Technical Service Bulletin 338C Model DDX-LP Valve Conversions

Model DDX-LP Valve Conversions

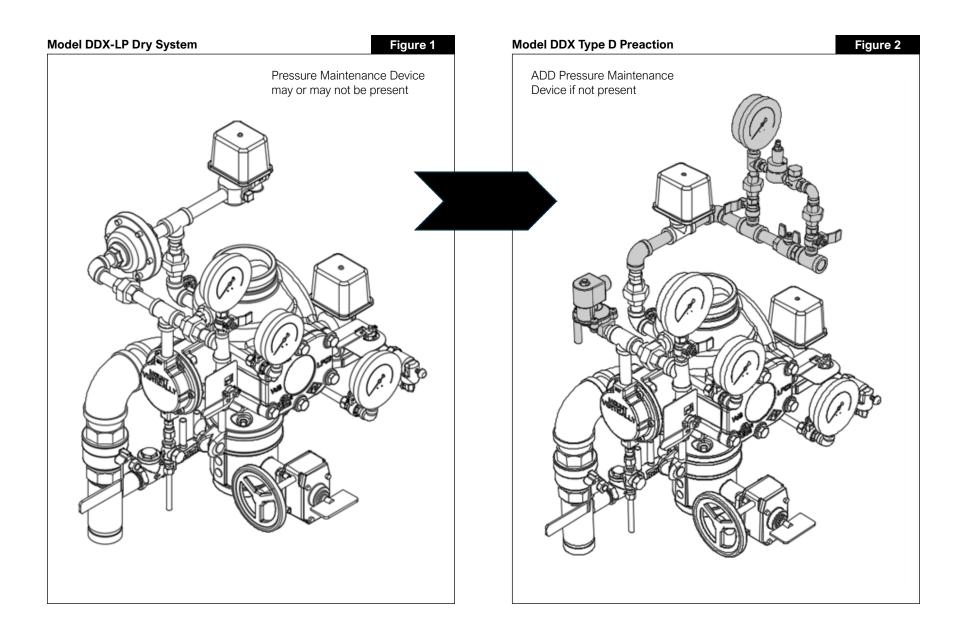
This conversion requires the installation of a normally closed solenoid valve upstream of the Model LP Dry Pilot Actuator, replacement of the valve identifier badge on the cover plate, and adjustment of pressure settings. Before and after images of the trim are provided in Figures 3 and 4 on Page 3. Conversion kit part numbers are provided below. The Type F system is an electric/pneumatic double-interlock preaction system. Following the conversion, an approved detection system with a listed release control panel must be provided to operate the system. The release control panel must be compatible with the solenoid valve.
